**Agenda Item B.1**  
**CONCEPTUAL/PRELIMINARY/FINAL REVIEW**  
**Meeting Date: February 10, 2026**

**SUBJECT:** 478 Cambridge Drive (APN 069-560-031)  
Community Assembly Parking Lot Lighting  
Case Nos. 25-0033-DRB, 24-0052-ZC

**PROJECT DESCRIPTION:**

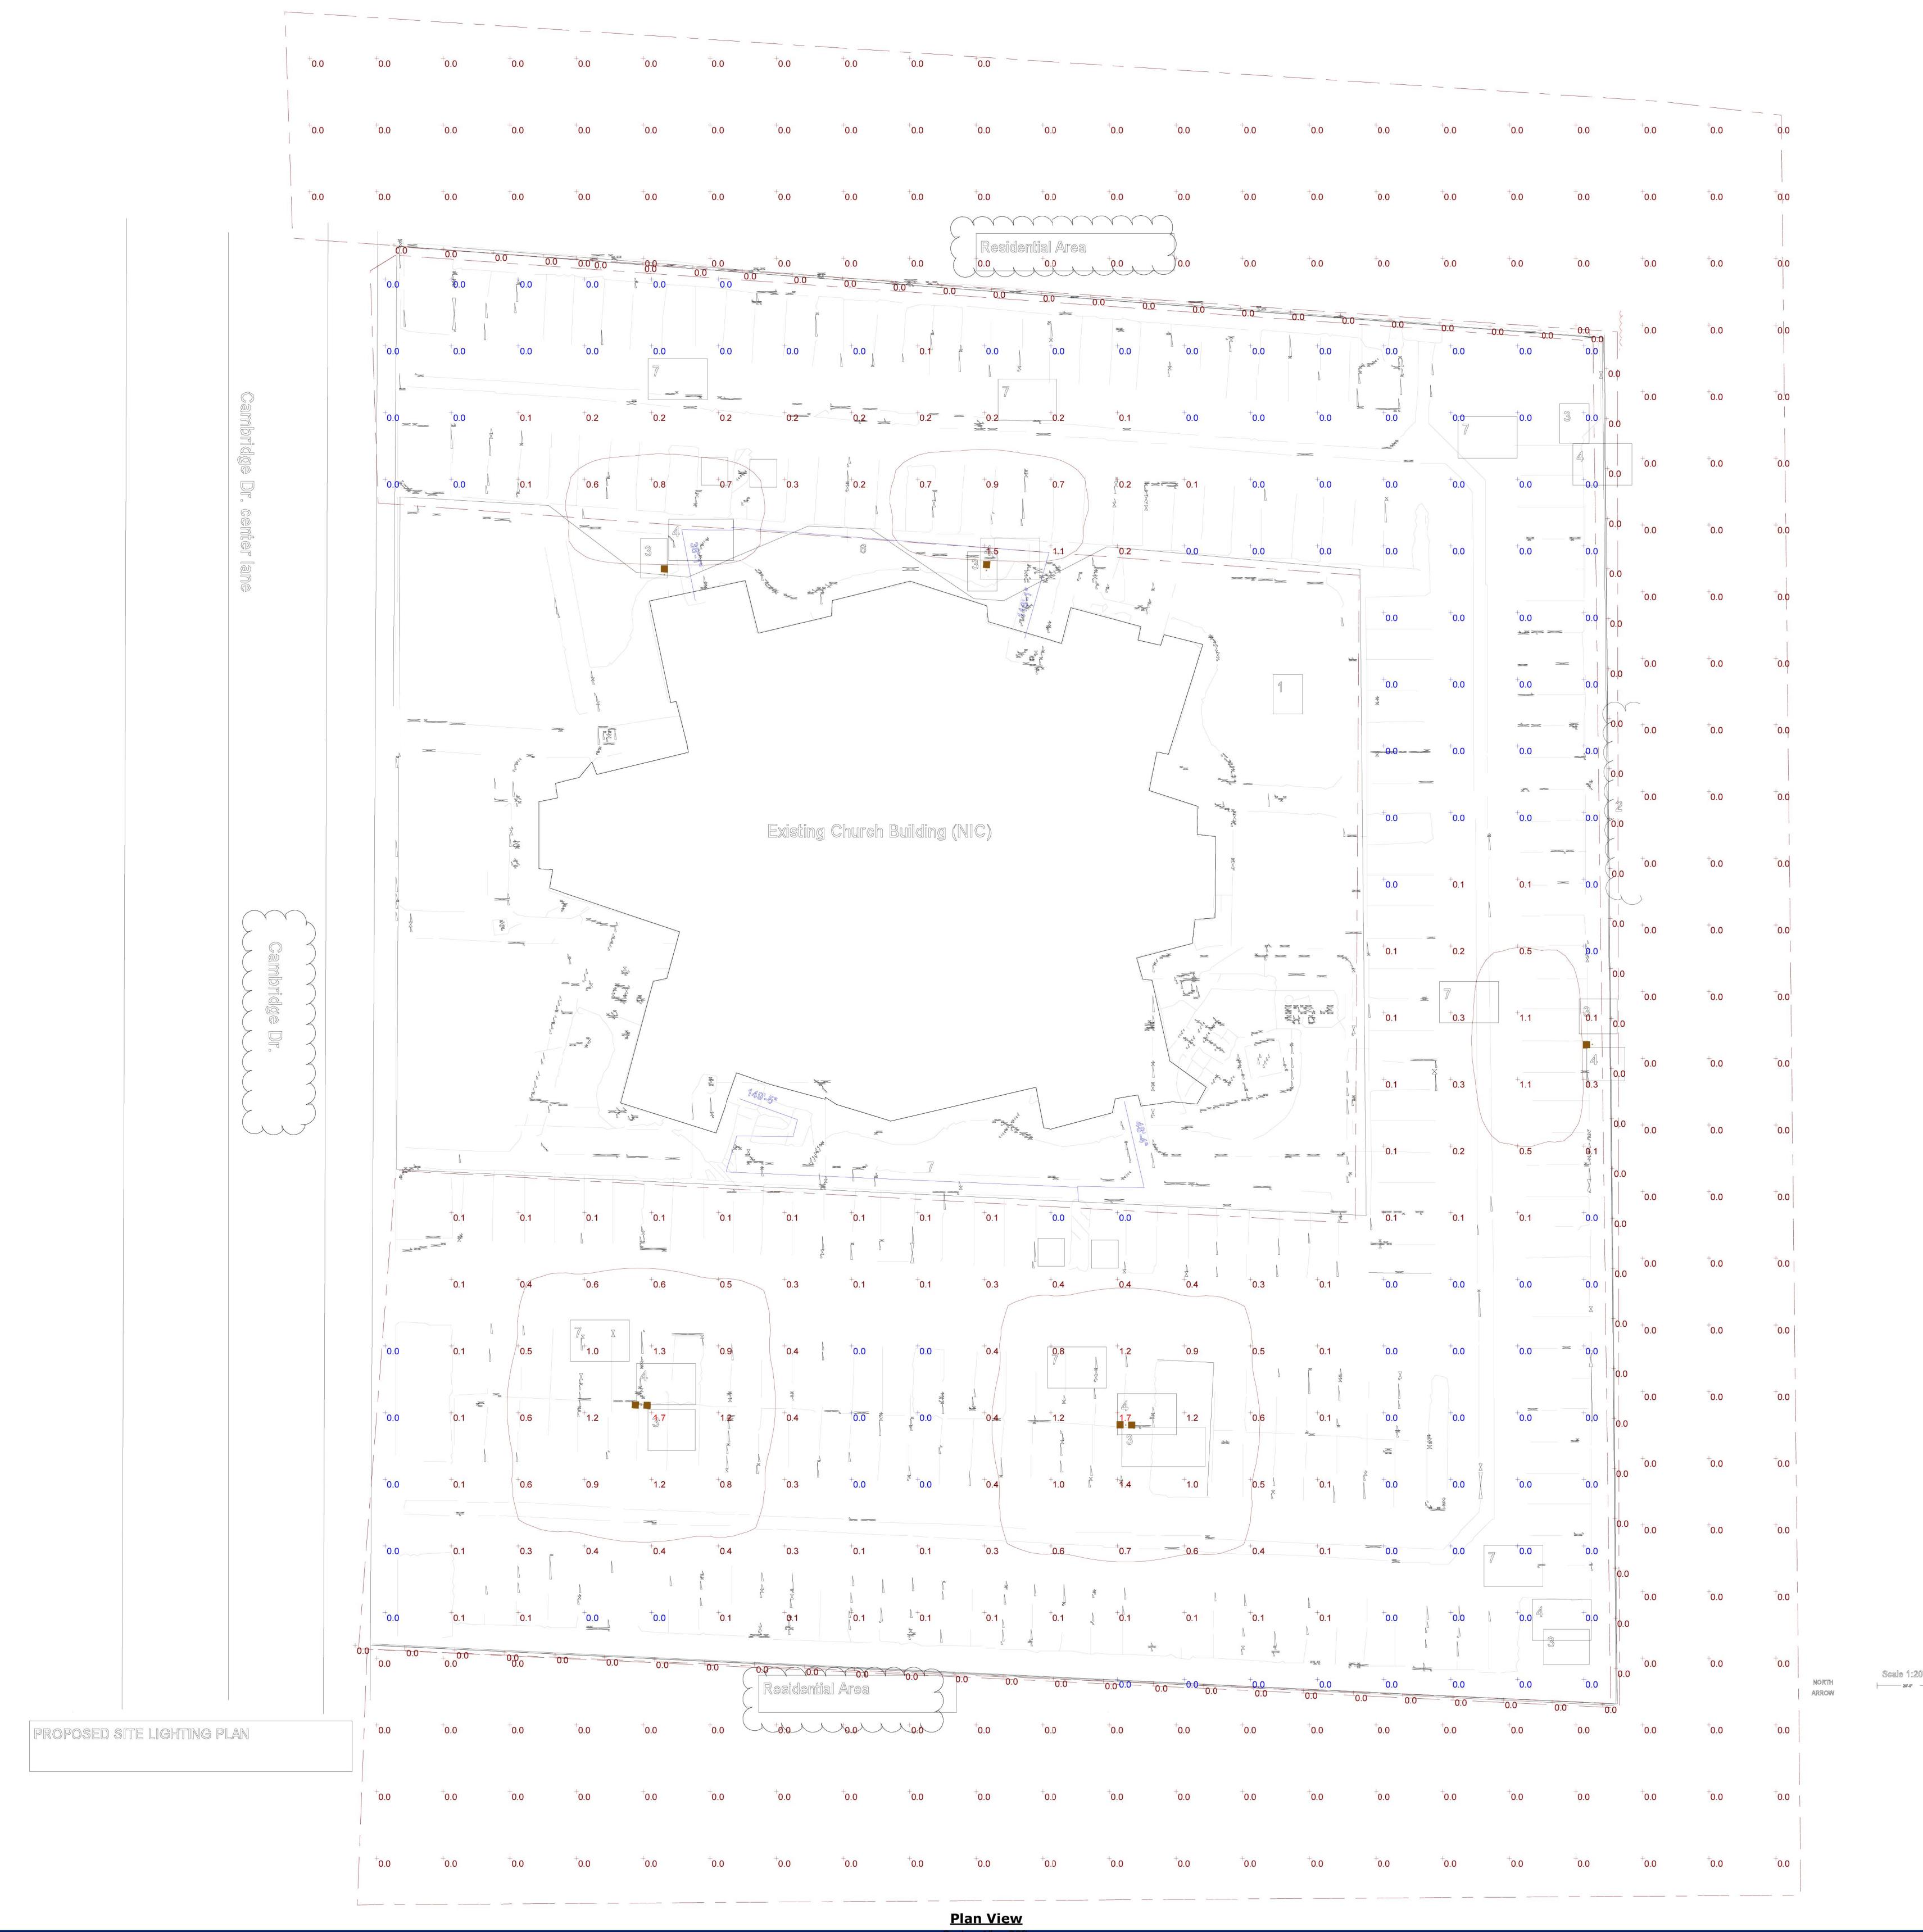
The photometric plan shows little overlap in the parking lot lighting while also providing lighting for safety in the parking lot. The photometric plan does not exceed 0.1 foot-candles at any of the property lines nor spill into the adjacent residentially zoned properties.

The proposed plan shows no light cast onto adjacent sites.

Section of page 9 of plans as submitted; photometrics (yellow shading) are incorrect:

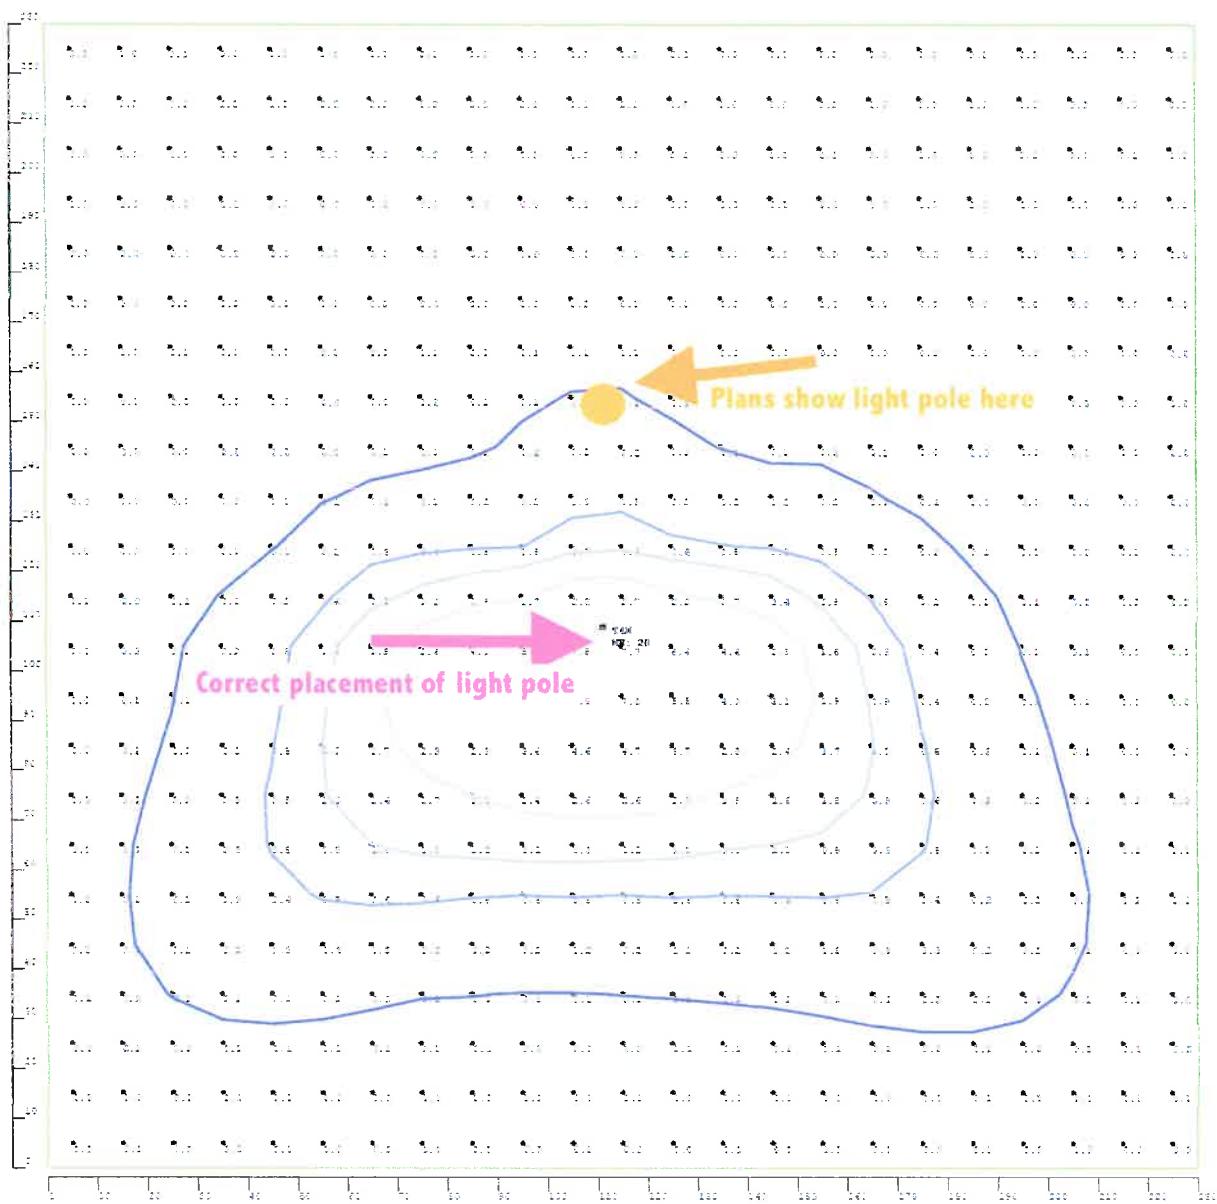
Multiple errors on placement of photometrics and foot candles on submitted plans

Photometrics (yellow shading) should be radiating from near the center of the light pole (per the light manufacturer), where I drew in the stars, but the applicant put the photometric shading in the wrong place. I moved one to its approximate correct location in the SE corner as an example here;

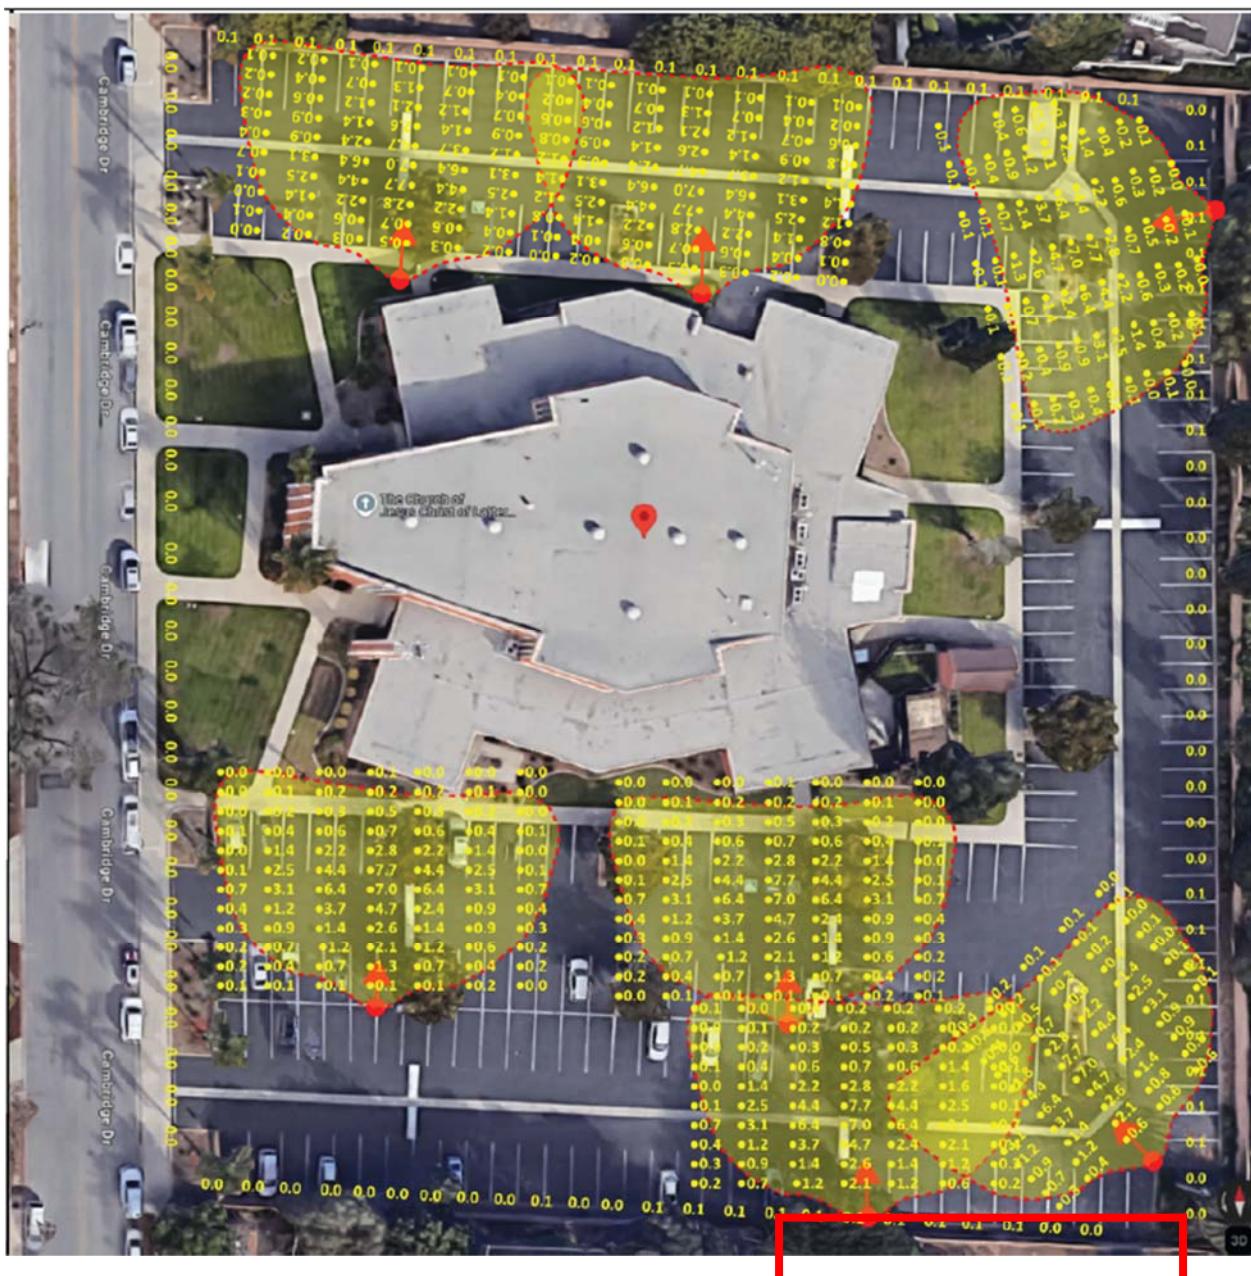
Continuing to comment on the inaccuracy in the drawing on page 6, the “approximate existing light distribution pattern” is just not accurate at all. This **one** light in the SE corner of the church property fully illuminates the church building approximate 150’ away and as indicated in my “approximation” below. Due to the angle of the light placement, it bathes many of the adjacent residential homes in “stadium” Lighting, it is literally daylight from dusk till dawn when this light is on.
